**TOWN OF LOS GATOS  
PLANNING COMMISSION AGENDA  
JUNE 25, 2025  
110 EAST MAIN STREET  
TOWN COUNCIL CHAMBERS  
7:00 PM**

DATE: June 20, 2025  
TO: Planning Commission  
FROM: Joel Paulson, Community Development Director  
SUBJECT: Consider a Request for Approval to Demolish an Existing Single-Family Residence, Construct a New Single-Family Residence, Site Improvements Requiring a Grading Permit, and a Zone Change from O (Office) to R-1:8 (Single-Family Residential, Minimum Lot Size of 8,000 Square Feet). **Located at 14331 Capri Drive.** APN 406-32-004. Architecture and Site Application S-24-043 and Zone Change Application Z-23-005. Categorically Exempt Pursuant to CEQA Guidelines Section 15303: New Construction, and Section 15061(b)(3): Common Sense Exemption. Property Owner: Ravi Kiran Vallamdas. Applicant: Gordon K. Wong. Project Planner: Ryan Safty.

**14331 Capri Drive**  
**Architecture and Site Application S-24-043**  
**Zone Change Application Z-23-005**

### Unbroken two story wall is not consistent with multiple Residential Design Guidelines

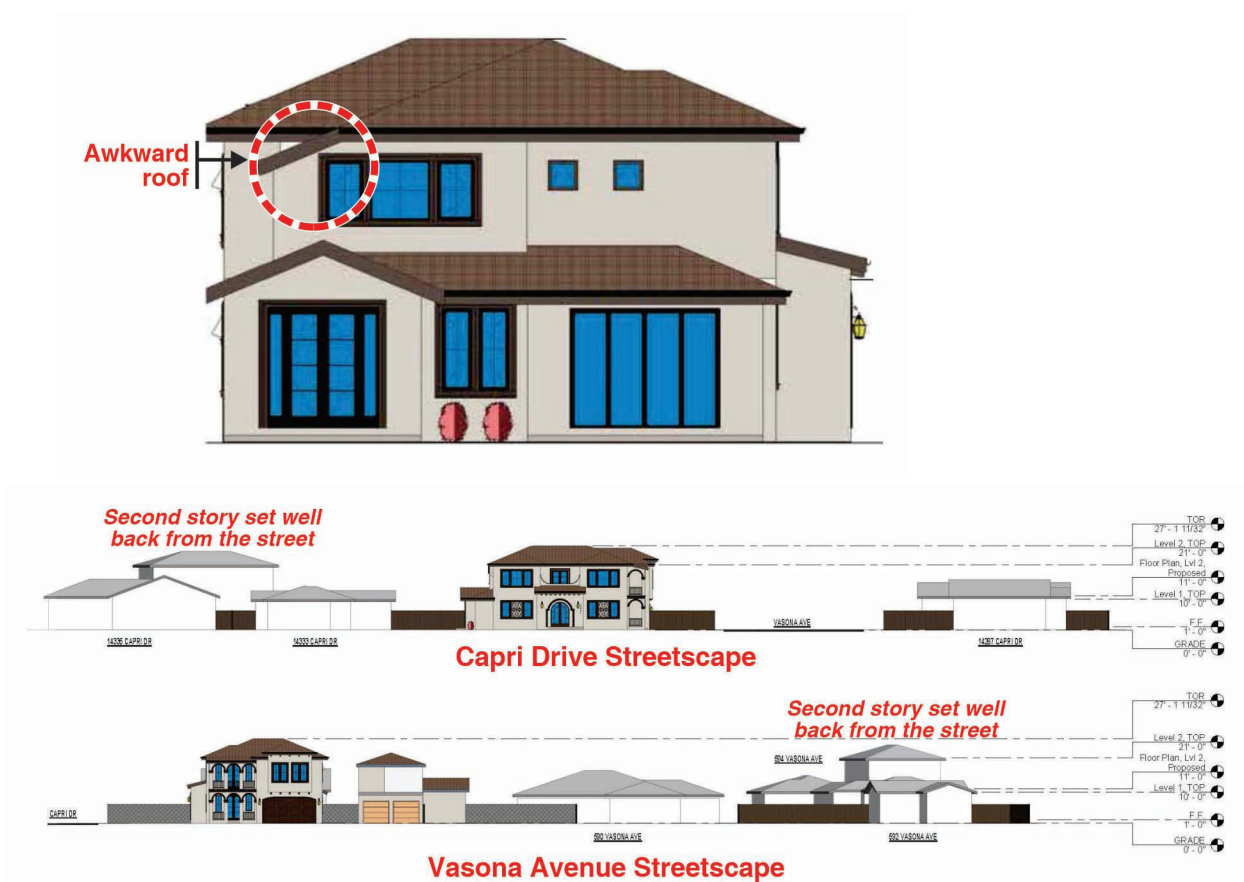
### Mass and bulk of the structure not consistent with the Residential Design Guidelines

### 2.3.1 Design two story houses in predominantly one story neighborhoods to blend with the smaller homes.

*FRONT ELEVATION: Currently Proposed*

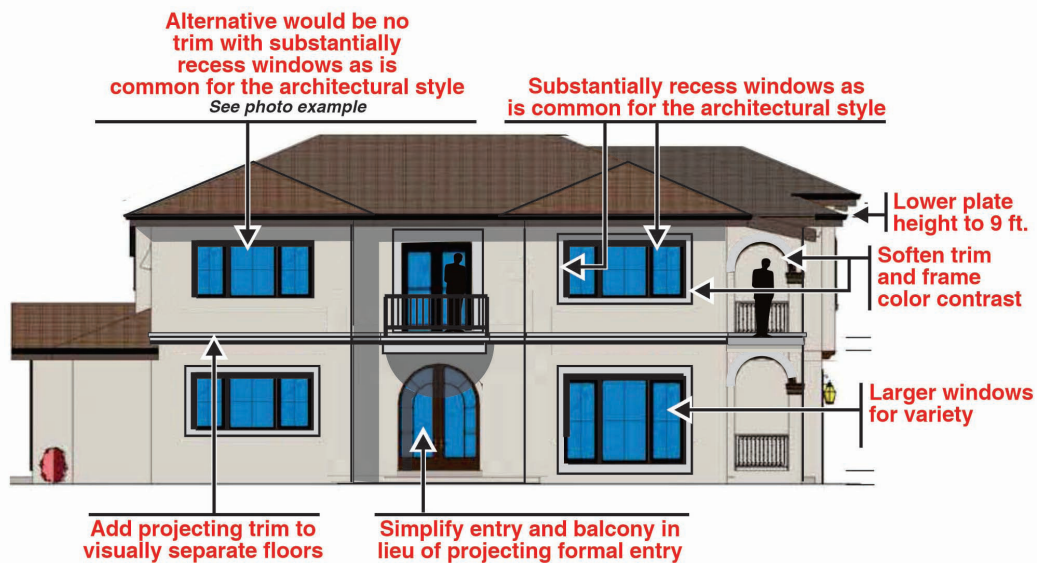
3. Provide larger windows on the Family Room front façade for more visual variety (RDG 3.7.1, 3.7.4).
  - *This recommendation was incorporated.*
4. Detail the windows to be more consistent with the proposed architectural style. Two options are possible that are consistent with the style - window frames or frameless windows with deeply recessed windows. Window sashes should be wide enough to be consistent with the style. Vinyl or metal cladding over wood are common modern equivalents to traditional wood windows. If trim is used, soften the color contrast with the house body color (RDG 3.7.4).

- *This recommendation was incorporated by softening the window trim color.*
5. Add projecting trim to visually separate the floors (RDG 2.3.1, 2.3.2, 3.3.2, 3.3.3).

*REAR ELEVATION: Currently Proposed*

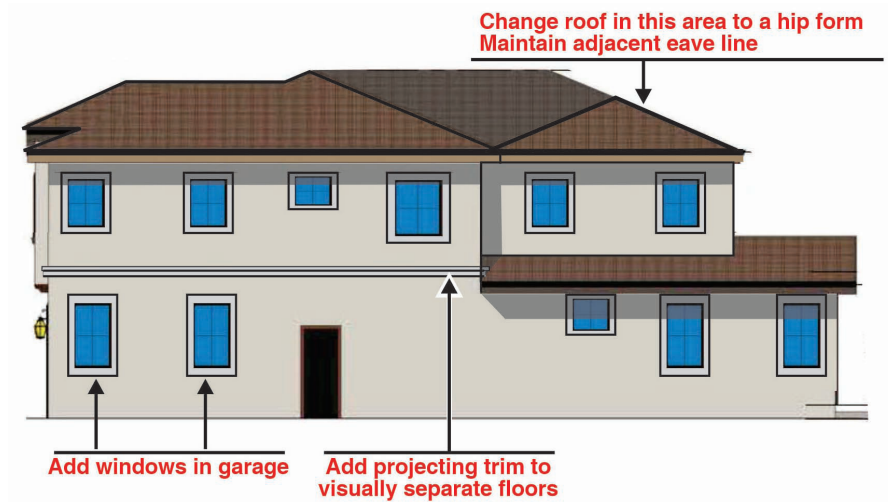
8. Change the extended roof overhang at the Master Bedroom on the rear elevation to a hip roof (not related to a referenced RDG).
  - *This cannot be done as it will result in a cricket in between the two hips. In addition, the roof was carefully designed in a way to reduce the amount of 'pointy' peaks while keeping the simplicity of the ridge lines (Exhibit 7).*
